From: Amanda Scholes on behalf of Planning.Responses
Sent: 24 June 2019 10:55
To: Planning Scanning
Subject: FW: F/30/18/PL - Drainage comments
Attachments: Barfoots - Sefter Farm Reservoir - Photo 1 - 19th February 2019.jpg; Barfoots - Reservoir - Updated Design - Cundall - 1st February 2017.pdf

Thank you for your comments concerning our application to erect multispan polythene tunnels at Wicks Farm, Ford – F/30/18/PL.

Project	SEFTER FARM RESERVOIR
---------	-----------------------

Title
CONSTRUCTION DETAILS

SECTION B-B - POND OVERFLOW DRAINAGE PIPE
(SCALE 1:50)

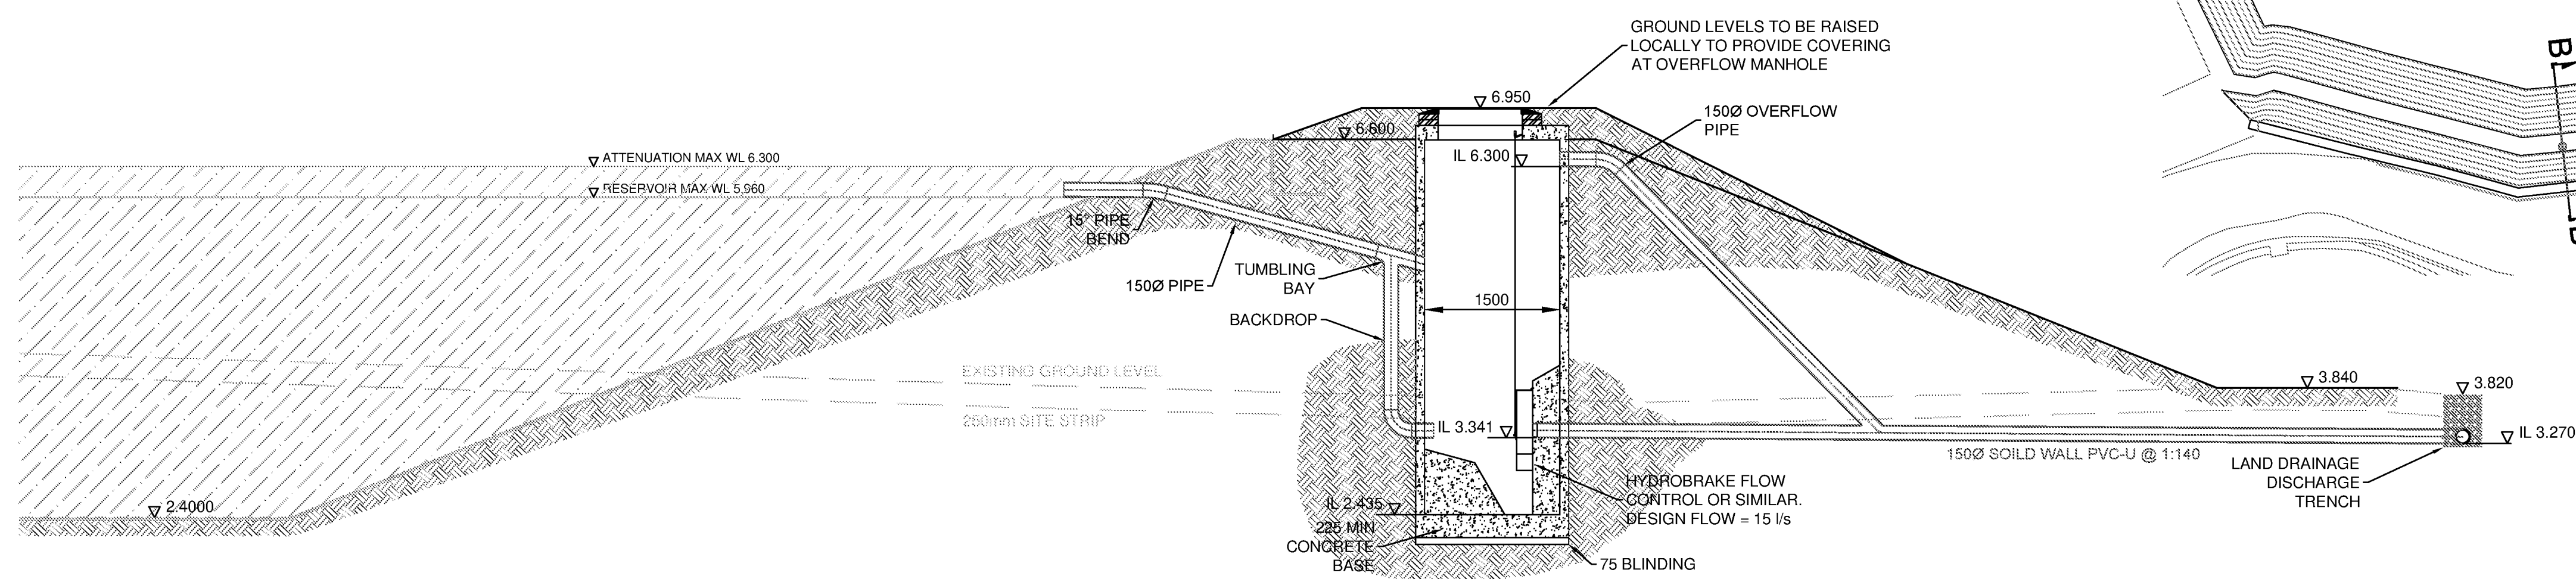
Can you please update the surface water drainage proposals to clearly show this proposed overflow to the ditch system?

I don't yet have the detailed design drawings for the proposed new reservoir at Wicks Farm; so I can't show you the detail of the overflow system; however; I'm attaching a copy of the design plans that we used for the new reservoir at Sefter Farm, Pagham. We completed that build in November 2018 and I've also attached a photo of the completed reservoir.
